State of California – A Natural Resources Agency
OFFICE OF ENERGY INFRASTRUCTURE SAFETY
715 P Street, 15th Floor | Sacramento, CA 95814
916.902.6000 | www.energysafety.ca.gov

NOTICE OF DATA INACCURACY

On July 22, 2026, and July 23, 2026, Energy Safety conducted inspections of Southern California Edison Company's 2026 Q1 WMP initiatives in the vicinities of the cities of San Jacinto, Perris, and Hemet, California. The inspection report is enclosed herewith. Energy Safety found the following data inaccuracies:

Structure ID: 64655S

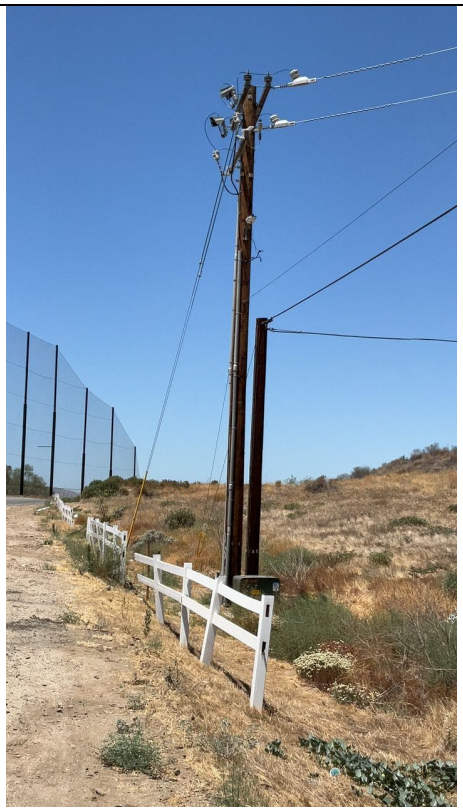
Data Inaccuracy Image 1-3: No line spacers installed near pole or midspan	**Data Inaccuracy Image 1-4**: No line spacers installed in between two subject poles

Structure ID: 1805134E

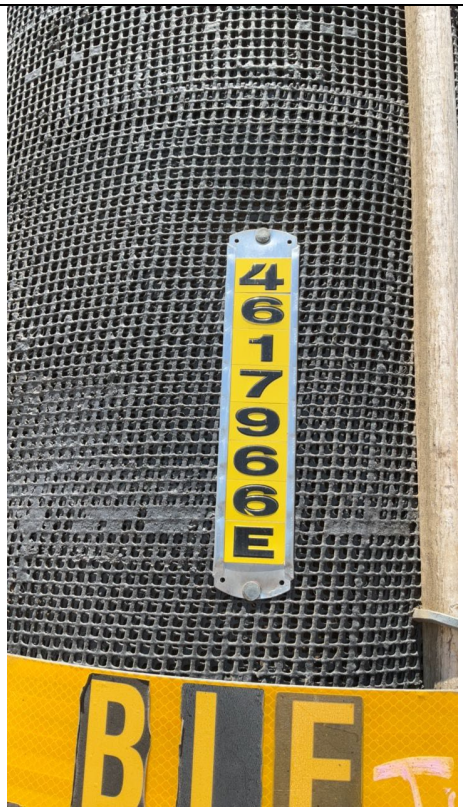
Data Inaccuracy Image 2-4: No line spacers installed between structure IDs 1805134E and 1805133E.

Data Inaccuracy Image 2-5: No line spacers installed between structure IDs 1805134E and 1805133E.

Structure ID: 4617966E

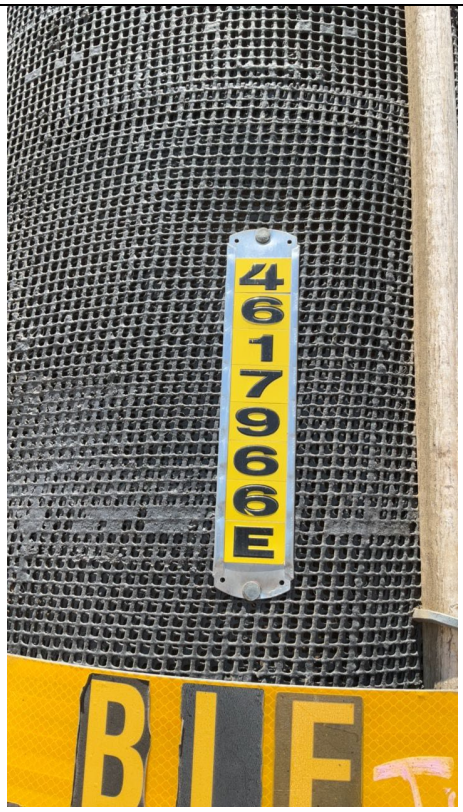
Data Inaccuracy Image 3-3: No line spacers installed between two subject poles.

Structure ID: 1804912E

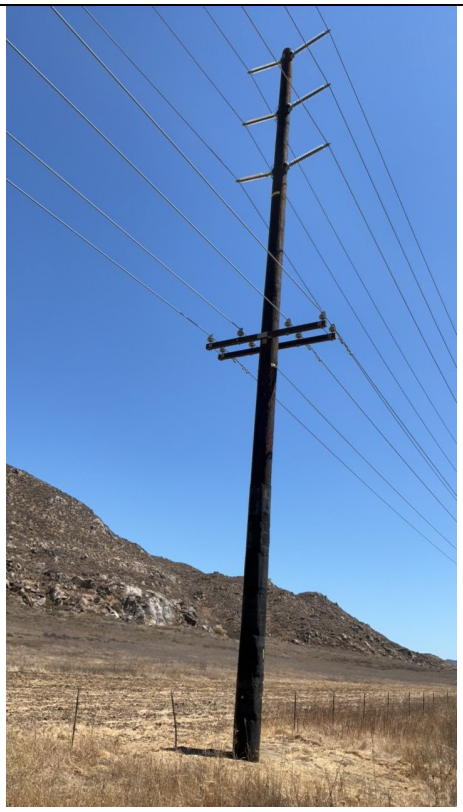
Data Inaccuracy Image 7-3: No line spacers installed in between structure IDs 1804912E and 1804913E
